DA Access Report

187-189 Adelaide Street, St Marys, NSW

This development proposes a New Building for a Childcare facility. The development is within Penrith Council LGA. A total of 1 Accessible parking space has been provided in the development.

[Image description: Plan of Basement level above shows the provision of Accessible parking space]

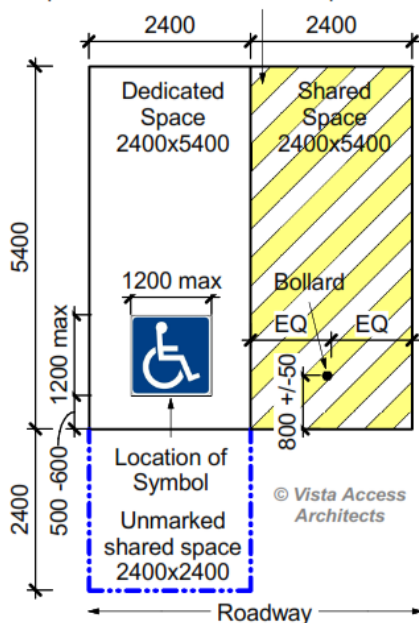
Requirement	Class 9b School - 1 Accessible car parking space per 100 spaces provided Other assembly building - 1 Accessible car parking space per 50 spaces provided and then additional 1 Accessible car parking space per additional 100 spaces provided
Compliance Comments	Complies. Total number of Accessible parking spaces required / provided in the development = 1. Detailed features of the accessible parking space to be verified at CC stage of works.
